Subdivision and Land Development Cover
Page for SLD # 07-22

Project Name: AIM Academy

Address: 1200 River Road

Date: June 22, 2022

DRAWING NAME: LANDSCAPE PLAN

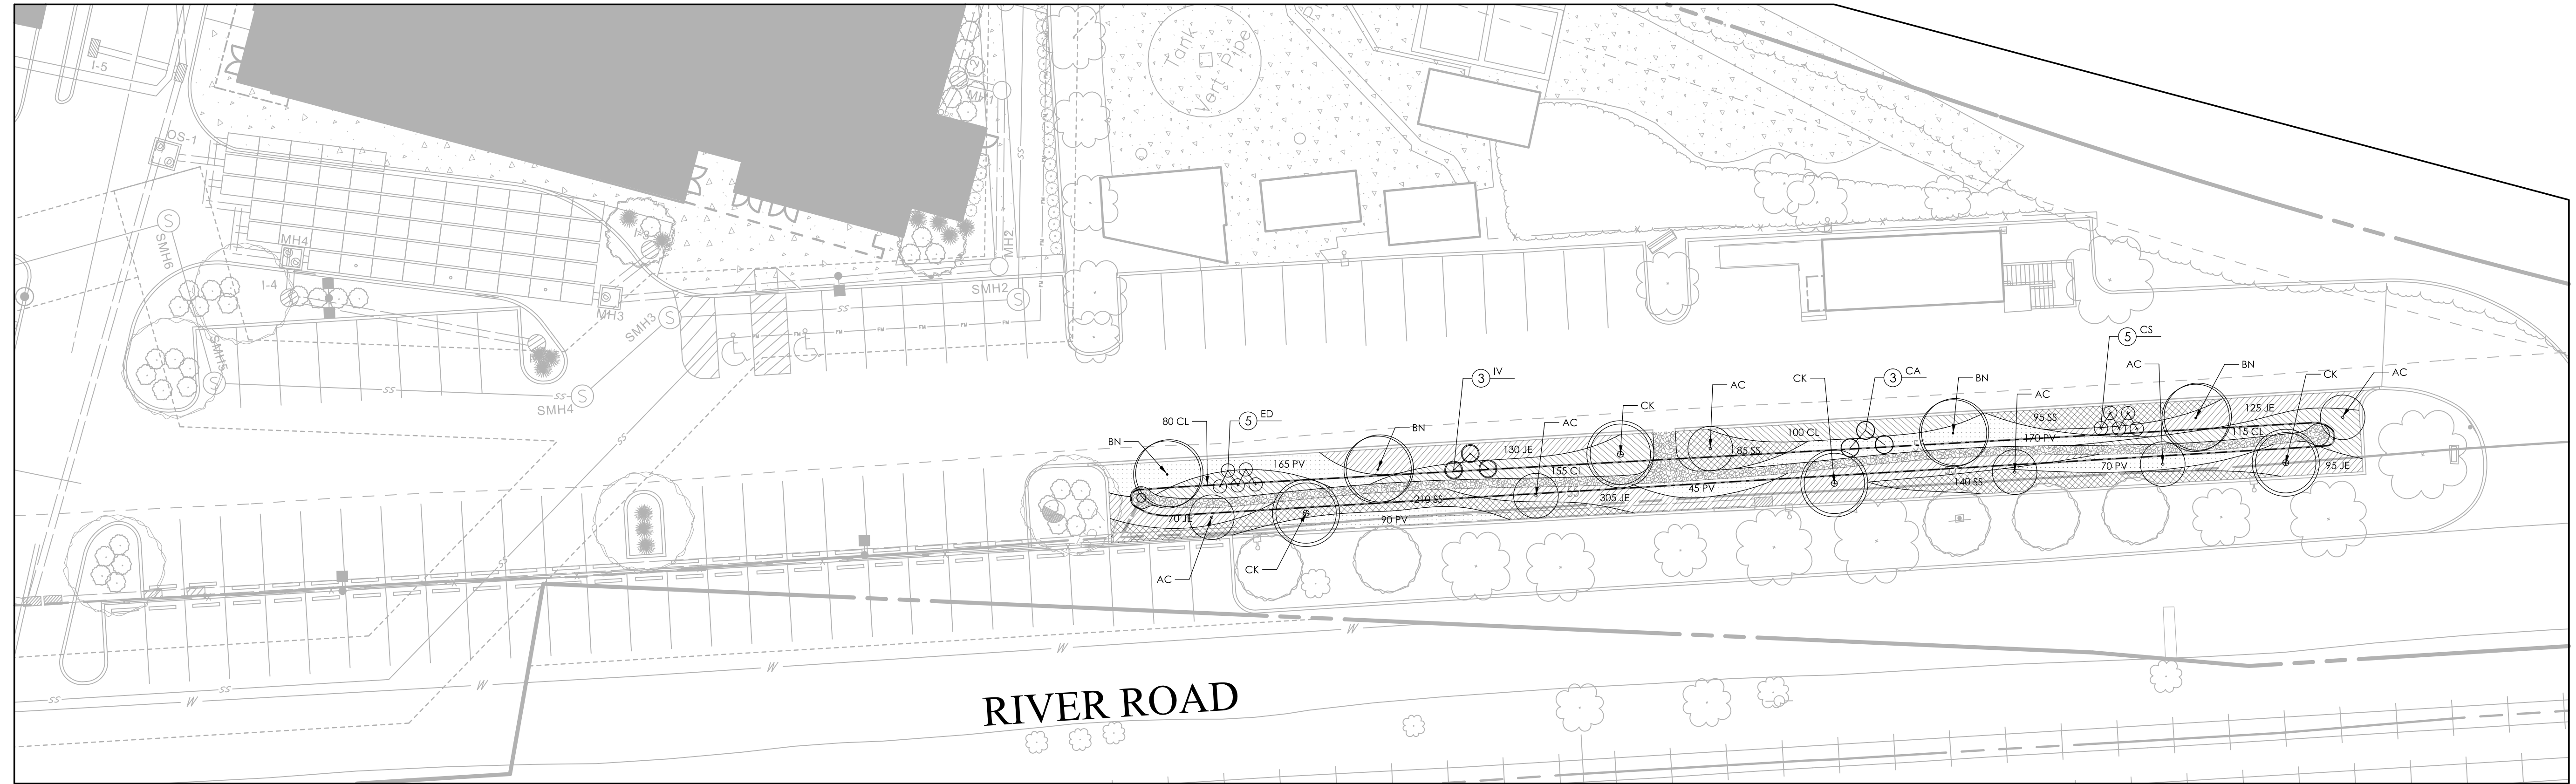
The applicant's plan (Sheet #6/12) proposes a 275 ft. long bioretention area that will replace a previously impervious asphalt parking bay. This is a positive development and will assist in mitigating the adverse impacts of parking lot rainwater runoff before it enters the Schuylkill River. We are concerned that the facility may not yield its potential environmental benefits due to the minimal planting of shrubs in very small groups. As well, there are only 11 shrubs proposed for a 275 ft. by 18 ft. wide area, which are widely spaced apart. (Note: the 5-Eupatorium 'Little Joe' - Joe Pye Weed is a perennial and doesn't persist in the winter which is a defining feature of shrubs). In accordance with best management practices, we recommend that bioretention areas rely upon a greater density of vegetative coverage provided by trees and shrubs, as opposed to coverage provided by perennials and grasses. Woody plants have a greater life span and will lower maintenance costs and minimize potential invasive plants and vines occupying the facility over time. In order to help ensure the effectiveness of the bioretention facility, we recommend the applicant modify the planting plan to include additional appropriate tree and shrub groupings.
